**SUBJECT: Minor Replat – Celebration Pointe - 5501 Peterson Road**  
**TECHNICAL REVIEW PROJECT: # 18-05000001**

**RE : Celebration Pointe Minor Replat  
5501 Peterson Road (Jenkins Road)  
TRC No. 18-05000001**

**Project: CELEBRATION POINTE – MINOR REPLAT**

**SUBJECT:** Minor Replat – Celebration Pointe  
5501 Peterson Road

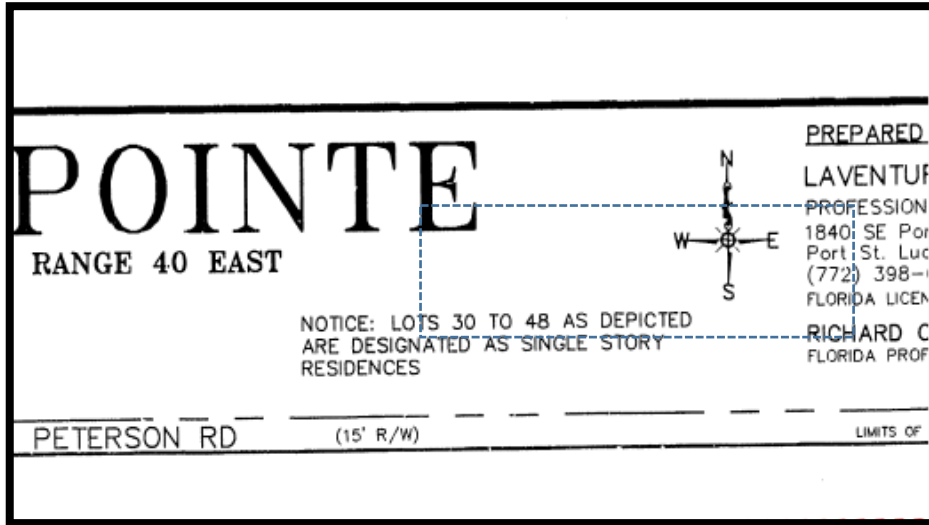
- 3) The subject Planned Development distributed 755 units throughout the project, appropriately situating the denser concentration of units (292 single-story villas & 145 two-story townhouses) at the southeast end of the site. This layout accounted for compatibility with adjacent Land Use and Zoning District, neighboring developments, as well as proximity to commercial and public facilities. A snapshot of the County’s Land Use & Zoning designations surrounding the project are presented

below, to highlight the low density uses to the west, northwest, and north of the affected area.

As the “Site Plan” presented within the Minor Replat application demonstrates an increase in density, specifically an additional 155 dwelling units within the project, an updated Traffic Impact Analysis and Concurrency application should be integrated into the subject request, and/or within an application Major Modification to the Planned Development.
